Access Compliance Report

Public Rights-of-Way

(Curb Ramps)

Intersection ID: 46305	Main Street: AUGUSTINE_WY	Cross Street: BECKET RIDGE_RD	Location: NW
ADA ID: 464C3DDD2340	Ramp Type: PerpDiag	Initial Pass/Fail: Fail	Overall Compliance: No
Severity Score: 10			
Codes/Mitigation Info/Possible Solution		Field Measurements/Component Compliance

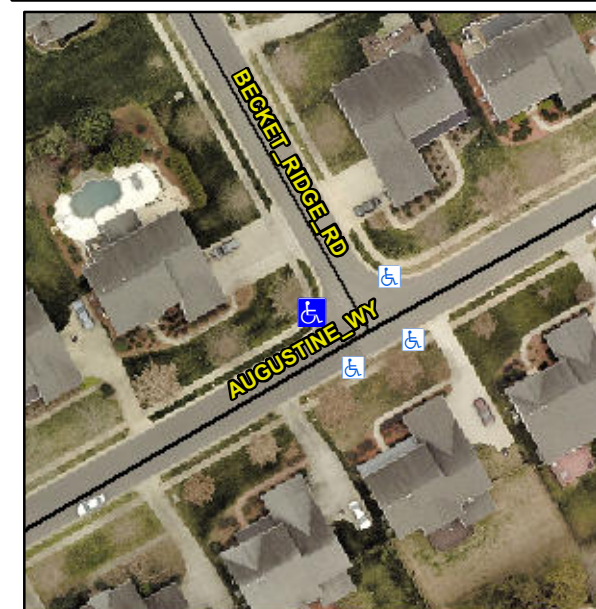
Not Found, R304.5.1, R304.5.3

Compliance	Description	Data	Compliance	Description	Data
N/A	Ramp Length (in)	50.0	Yes	Ramp Slope (%)	7.4
No	Ramp Width (in)	38.5	No	Ramp XSlope (%)	2.9
N/A	Flare Type LT	N/A	N/A	Flare Type RT	N/A
N/A	Flare Slope LT (%)	N/A	N/A	Flare Slope RT (%)	N/A
N/A	Flare Traversable LT?	N/A	N/A	Flare Traversable RT?	N/A
N/A	Landing Length (in)	N/A	N/A	DWS Provided?	N/A
N/A	Landing Width (in)	N/A	N/A	DWS Contrast?	N/A
N/A	Landing Slope (%)	N/A	N/A	DWS Length (in)	N/A
N/A	Landing X Slope (%)	N/A	N/A	DWS Full Width?	N/A
N/A	Landing Curb? (Y/N)	N/A	N/A	DWS Offset (in)	N/A
N/A	Shared Landing?	N/A			
N/A	Gutter Ponding?	N/A	N/A	Gutter Slope (%)	N/A
N/A	Gutter Lip Ht (in)	N/A	N/A	Gutter X Slope (%)	N/A
N/A	Painted X Walk1?	No	N/A	Painted X Walk2?	No
	X Walk 1 Direction	To S		X Walk 2 Direction	To E
N/A	X Walk 1 Width (in)	N/A	N/A	X Walk 2 Width (in)	N/A
	X Walk 1 Slope (%)	3.3		X Walk 2 Slope (%)	2.0
	X Walk 1 X Slope (%)	0.7		X Walk 2 X Slope (%)	4.4

Remove & Replace Curb Ramp With Two New Directional Ramps or Equivalent.
